RE: PC24093 – Lot 25 Stirling Crescent, Hazelmere, WA Stormwater Disposal Strategy & Management Plan

In response to DBCA's comments on the initial SMP submission made on the 30 May 2024, we have updated the SMP to address DBCA and council comments and provide a response schedule in **Appendix D**.

STORMWATER MANAGEMENT PLAN

PROJECT NUMBER: CI-SK.01
 DATE: MAY 2024

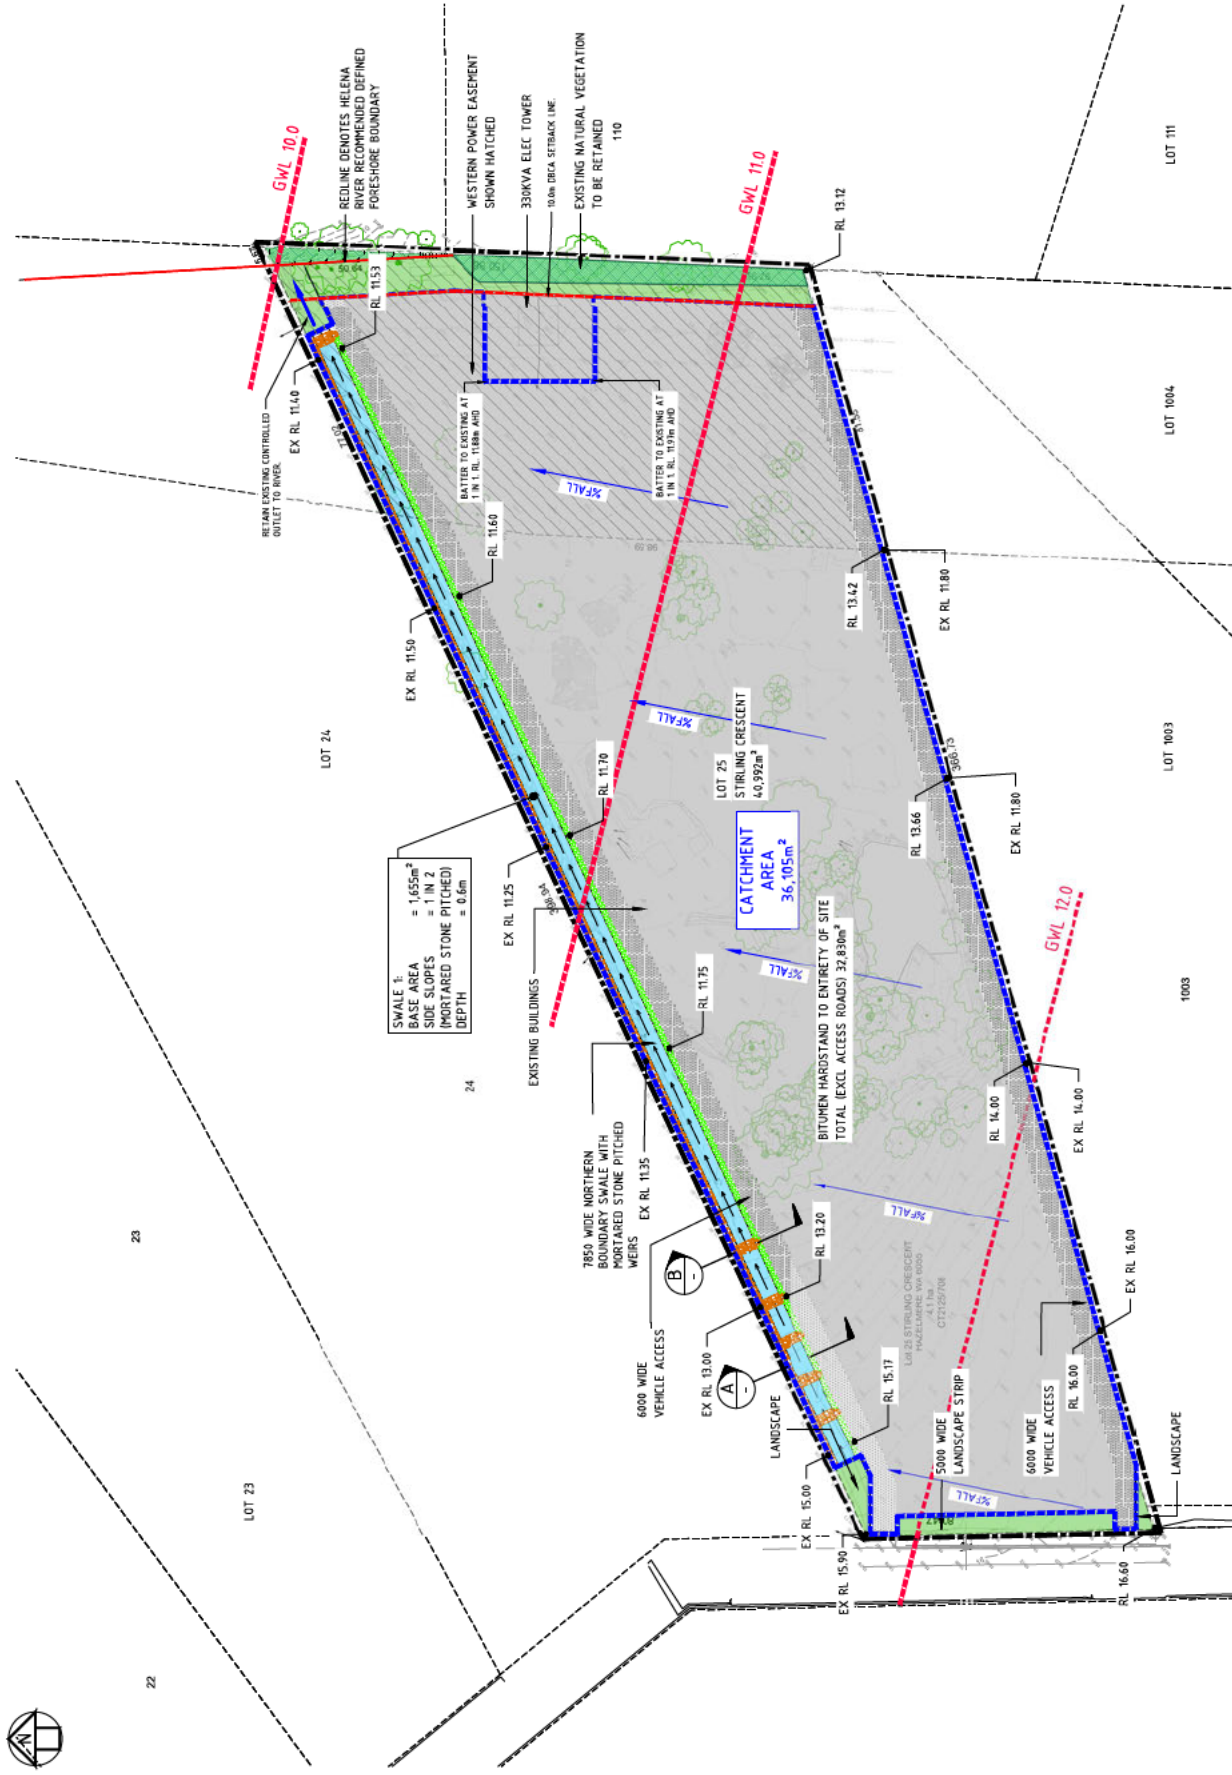
DBCA comment	Required
<p><i>A 10 metre setback to the Swan Canning DCA boundary in accordance with Policy No. 48 – Planning for development setback requirements affecting the Swan Canning DCA.</i></p>	<p>SMP PLAN (Peritas Drg PC24093-CI-SK01) has been updated to show the 10m setback line.</p>
<p><i>1. Pre-development flow rate for 20% AEP event is estimated to be 211 L/S and the post development flow rate for 20% AEP is designed to be no higher than 211L/S. It is also important to plan for the pre and post-development flow rates for the 1% AEP as it is understood that this will also be managed through the site and discharge to the river.</i></p>	<p>Peritas confirm that the design of the stormwater system complies with the nominated criteria. Note that the allowance outflow has been reduced to 195 litres/sec (pre-development flow) due to the reduction in hardstand area and hence the calculated catchments contributing to the swale storage requirements.</p>

<p><i>a. Plan indicates swale will have side slopes 1:1 and stone pitched. This is not supported. Vegetated slopes are recommended.</i></p>	<p>PC24093-CI-SK01 – SMP has been updated to reflect 1 in 2 side slopes with vegetation as per TDL landscape concept plans.</p>
<p><i>b. Provide planting list and densities. As the swale is designed to accommodate up to 1%AEP, swale planting should be separated into wet and dryland planting to increase survival rates of plants and to ensure that the swale is effective at providing water quality treatment.</i></p>	<p>N/A for Peritas Scope</p>

<p><i>c. The plan should provide outfall details/overland flow path to the river. Information is required regarding the existing condition and if any additional erosion/scour protection and planting will be required.</i></p>	<p>The Peritas SMP plan shows the overland flow path to the river, predominantly via the northern swale.</p> <p>TDL to include erosion management details on landscape plan.</p>
<p><i>2. Alternative design options have not been provided. Drainage swales are generally designed for stormwater conveyance as opposed to water quality treatment. As an alternative option, can biofilters be considered adjacent to the road (that runs parallel to the swale) to treat the first 15mm, with excess stormwater flows to discharge to the drainage swale.</i></p>	<p>TDL has enhanced the plan to include swale filtration planting.</p> <p>The swale filtration planting extends the length of the northern drainage swale to act as a biofilter.</p>
